Memorandum

Re: Further Information Response Part 1 – Bendigo-Ophir Gold Project Fast-track Application

Figure 1: Shepherds Creek Potential Cofferdam Locations

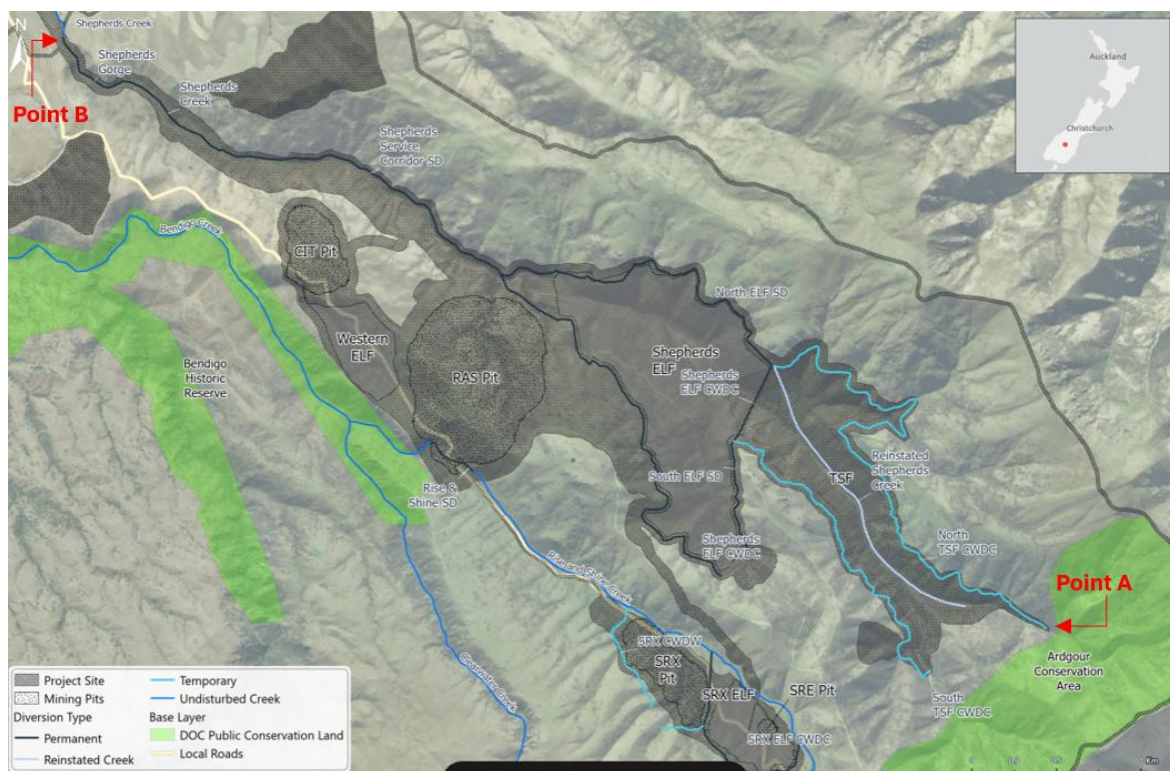
- Please provide NZTM2000 coordinates and / or a map to show the approximate location of any culverts or other instream structures that are proposed to be installed within watercourses on the site. A land use consent has been sought to install four culverts in the beds of Shepherds Creek and Rise and Shine Creek, as well as flow control devices and coffer dams but only the culvert in Rise and Shine Creek has been identified.*

With respect to cofferdams, an initial cofferdam is proposed that will form the starter embankment for the Shepherds Tailings Storage Facility. This is shown in *B.21 Shepherds Tailing Storage Facility Technical Report* (Figure 14 – Starter Embankment Layout) at approximately NZTM E1319731 N5017166. In addition, the proposed reclamation of approximately 3.1 km length of Shepherds Creek to establish the Shepherds Service corridor will effectively result in the diversion of Shepherds Creek at various stages from above the TSF and down to the processing plant area. This will involve the placement of several sequential cofferdams in the bed of Shepherds Creek. While the specific locations cannot be determined until detailed design they will generally be placed between E1321610 and N5015739 at the uppermost point of the TSF (Point A) and E1315592 N5019299 below the process plant area (Point B). These locations are illustrated in Figure 1 below.
